LINCOLN CITY/LANCASTER COUNTY PLANNING STAFF REPORT

PROJECT #: Special Permit #06034

PROPOSAL: Change the zoning from B-2 Planned Neighborhood Business to R-5 Residential and approve a Community Unit Plan for 54 dwelling units.

**Review Comments for
Application #: SP06034
KING RIDGE TOWNHOMES**

SITE PLAN

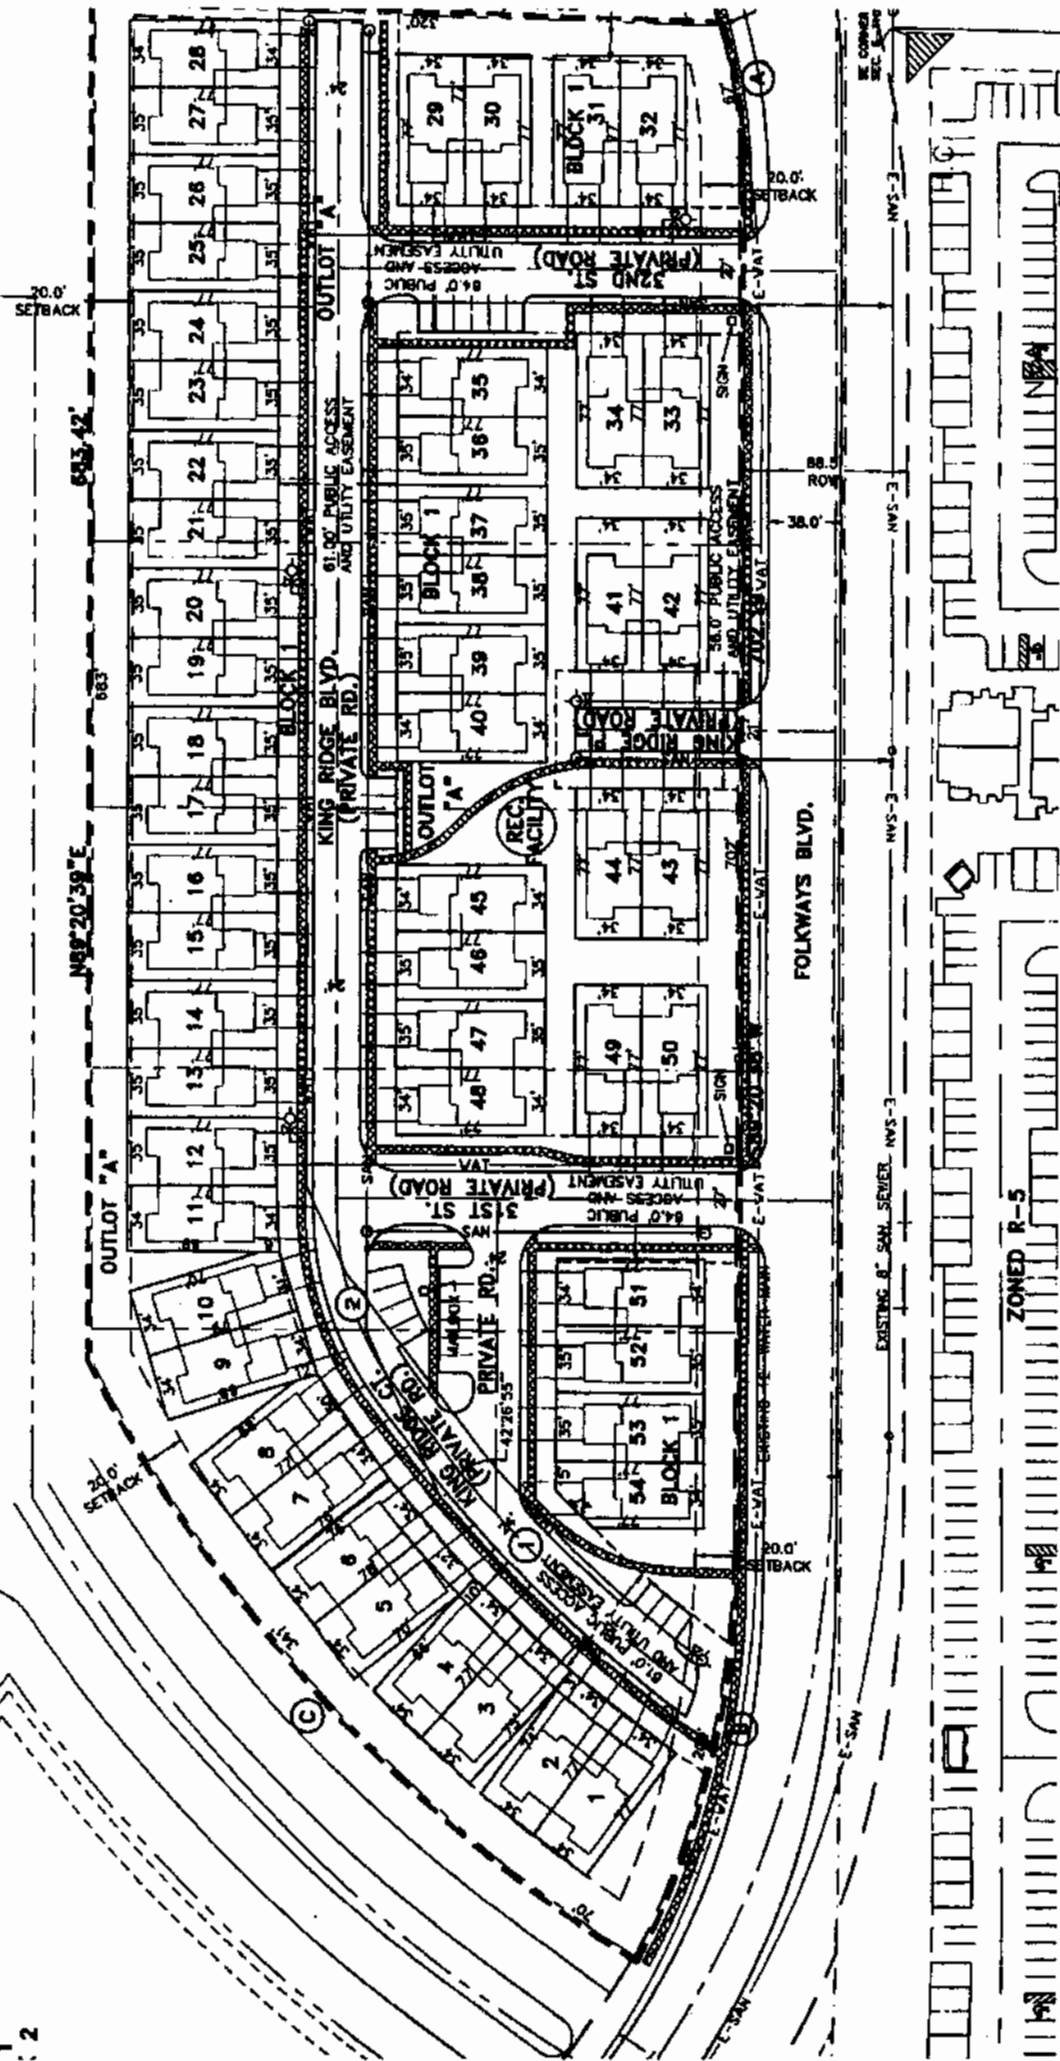
4. Due to the existing addressing pattern on the south side of Folkways Boulevard, 31st Street should be a named road rather than an numbered road. Also, 32nd Street should be preceded by the word "North." There is also an east-west private road shown intersecting King Ridge Court and 31st Street. This road must be named.

5. The outdoor recreation space proposed is inadequate. The Parks Department has requested a half basketball court, composite play structure, and shaded seating area.

8. The requested waiver of a sidewalk along the east side of King Ridge Place is unacceptable to city staff. A sidewalk at this location would provide increased

connectivity and safer mobility for the residents. Further, the sidewalk should extend around the end of King Ridge Place to serve the recreation facility.

9. The public access easement along the west end of King Ridge Court should be expanded to include the sidewalk next to Lot 54. Also, the dimension for the east side of Lot 54 must be corrected.
10. The proposed dead-end roads are unacceptable. Provision must be made to allow a vehicle to get turned around, either by constructing a hammer-head style turnaround or allowing driveways to be used for that purpose.
11. Changing the zoning on this property is consistent with zoning on the south side of Folkways Boulevard. The zoning could be changed to R-4 and applicant would have enough density for the proposed number of units, but R-4 would require greater deviations from the zoning requirements. Under R-5, either the CUP or straight zoning would allow up to 190 units, provided open space and parking requirements were met.

Comments: **numbered streets should have North as a prefix.**

The street named 31st should be a named street. The enormous apartment complex west of this street is 3101.

Comments: **1. Outdoor Recreation needs to be addressed and should include:**

- A. Basketball play court (half court with basketball goal)**
- B. Composite play structure meetin CPSC and ADA guidelines**
- C. Shaded seating area for adult supervision**

(4.1) A note needs to be added stating that the drive ways for Lots 1, 41, and 44 will function as turnarounds in lieu of the standard turnarounds.

- 5.1 Add a sidewalk to the east side of King Ridge Place, unless the requested modification to the land subdivision ordinance eliminating this sidewalk is approved by the City Council.

- 5.2 Add a note stating garages shall be located at least 22 feet from the sidewalk.
 - 5.3 Rename 31st Street with a name rather than a number, add the prefix "North" to 32nd Street, and name the east/west private road between King Ridge Court and 31st Street.

- 5.6 Add a note stating driveways at the dead-end of private roadways may be used by vehicles for turning around.
 - 5.7 Expand the public access and utility easement at the west end of King Ridge Court to encompass the sidewalk next to Lot 54.

- 5.8 Correct the dimension of the west lot line of Lot 54.
 - 5.9 Revise the recreation plan to show a half basketball court, composite play structure, and shaded seating area.
